SERVICE BULLETIN

FUJI HEAVY INDUSTRIES LTD.

NO : FAS-041

1. SUBJECT : Improvements, Steering Mechanism.
2. AIRCRAFT AFFECTED : FA-200 Series Serial Nos. 1 thru 75.
3. PRIORITY : Optional.
4. REASON : In order to improve steering performance and also to facilitate maintenance.
5. DESCRIPTION : This Service Bulletin provides instructions for two type of modification, Change No. 1 and Change No. 2, either of which will be adopted at your option.

FIG. 4 MODIFICATION OF STEERING MECHANISM - CHANGE NO. 2

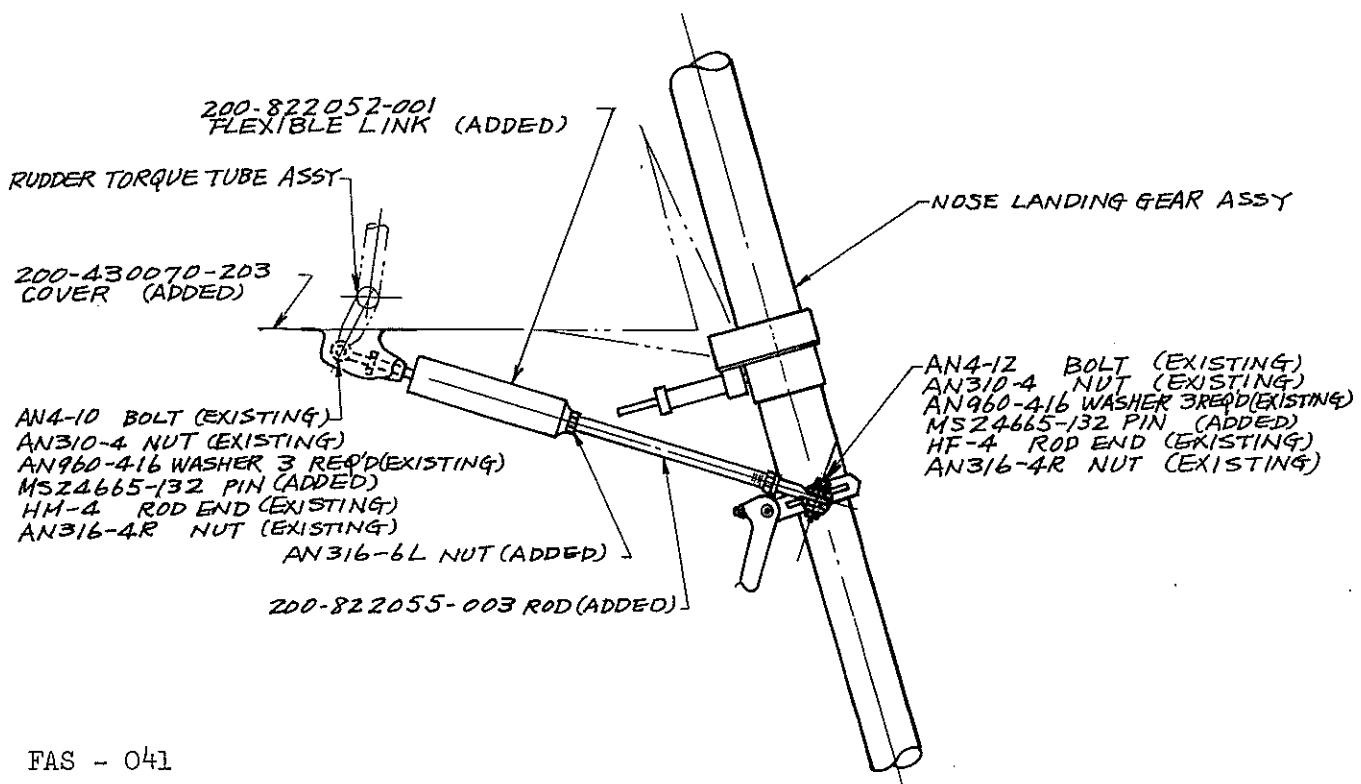
Change No. 2 : To modify nose landing gear steering installation, in addition to the modification contained in Change No. 1.
6. ACCOMPLISHMENT : Optional.
7. APPROVAL : JCAB Approved.
8. PARTS REQUIRED : The following parts are required to perform the modification:

Change No. 2 (Refer to figure 2 thru 4):

- a. Remove each two nuts, AN4-12 and AN4-10, four nuts, AN310-4, twelve washers, AN960-416, and four pins, MS24665-132 from nose landing gear cylinder and rudder torque tube side. And then remove two flexible link assemblies, 200-822018-001 and each cable assembly, NAS305R01-0117 and NAS305R01-0104.
- b. Separate each two rod ends, HF-4 and HM-4, and each two lock nuts, AN316-4R and AN316-4L, from the above flexible link and cable assemblies.
- c. Remove fuselage No. 1 access cover, 200-430070-157.
- d. Jack up airframe.
- e. Cut lockwire, MS20995C32, remove four bolts, 200-822160-003 securing nose landing gear upper stopper, 200-822152-003, and then remove the stopper.

- k. Reassemble nose landing gear assembly in accordance with Service Manual, para. 9-4-9. Replace existing cylinder assembly, 200-822130-101, with new cylinder assembly, 200-822130-201, and also replace all O-rings on reassembly. Stamp required information on #1 and #2 placards as illustrated in figure 5, and using EC-870 adhesive, bond to nose shock strut on the area as indicated in figure 4. Hand write pressure indication marking (lettering) on the area as shown in figure 4, referring to the instruction in figure 6.

FIG. 1 MODIFICATION OF STEERING MECHANISM - CHANGE NO. 1

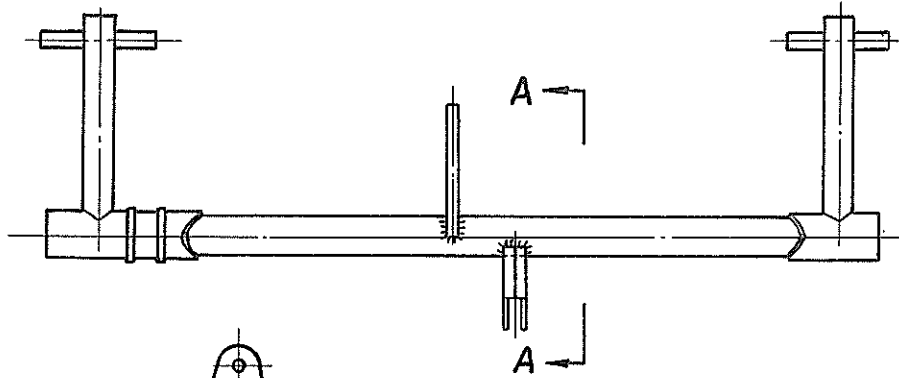
Change No. 1 : To provide new, improved steering mechanism, and also to modify rudder torque tube and related parts.

Change No. 1 (Refer to figures 1 thru 3):

- a. Remove each two nuts, AN4-12 and AN4-10, four nuts, AN310-4, twelve washers, AN960-416, and four pins, MS24665-132 from nose landing gear cylinder and rudder torque tube side. And then remove two flexible link assemblies, 200-822018-001 and each cable assembly, NAS305R01-0117 and NAS305R01-0104.
- b. Separate each two rod ends, HF-4 and HM-4, and each two lock nuts, AN316-4R and AN316-4L, from the above flexible link and cable assemblies.
- c. Remove fuselage No. 1 access cover, 200-430070-157.
- d. Rework rudder rear torque tube as illustrated in figure 2.
- e. Rework rudder front torque tube as illustrated in Fig 3.

- f. Assemble new flexible link assembly, 200-822052-001, and rod end, 200-822055-003, using each rod end, HF-4 and HM-4, two lock nuts, AN316-4R, that have been removed in the above step 13-1-2, and another lock nut, AN316-6L.
- g. Install new fuselage No. 1 access cover, 200-430070-203.
- h. Attach the new flexible link assembly and rod, with piston end afterward, to rudder front torque tube and to nose landing gear right side lug as shown in figure 1. Temporarily secure with existing each bolt, AN4-10, two nuts, AN310-4, six washers, AN960-416, and new two pins, MS24665-132.

FIG. 2 RUDDER REAR TORQUE TUBE

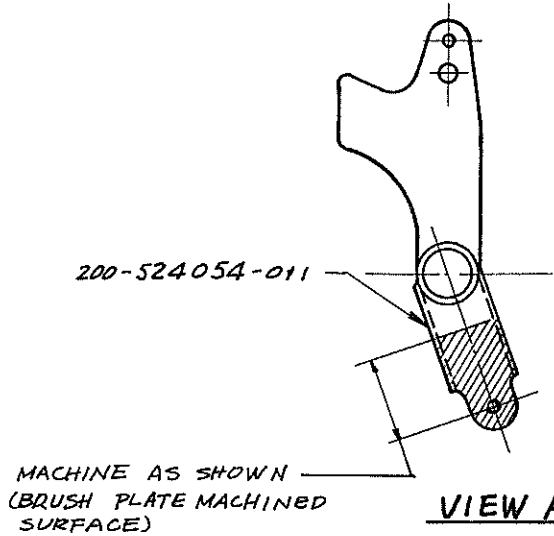
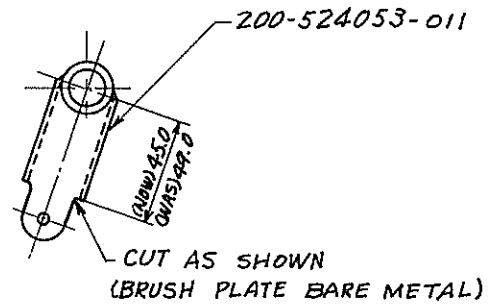
- o. Lower and remove jack.
- p. Rework rudder rear torque tube, 200-524054-1, as illustrated in figure 2.
- q. Rework rudder front torque tube, 200-524053-1, as illustrated in figure 3.
